PROPOSAL FOR NC DCC REQUIREMENTS OF GENERAL APPLICATION

The aim of this document is to synthesize the technical proposal of Elia, as relevant system operator or relevant TSO, regarding the Belgian implementation of the non-exhaustive requirements stated in the NC DCC. This document is the final version of the proposal for requirements of general application (hereafter named as 'general requirements', in accordance with Art. 6(4) of the NC DCC.

Figure 1 Overfrequency and underfrequency withstanding capabilities

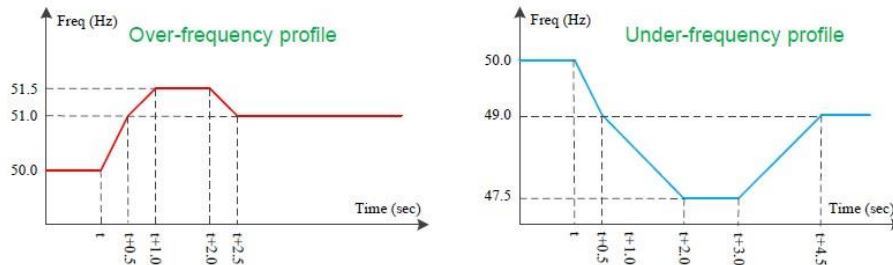
Commented [A8]: In dit hoofdstuk staat geen enkele verwijzing naar een mogelijke vergoeding voor diens naar het neutraliseren van de impact op de BRP.
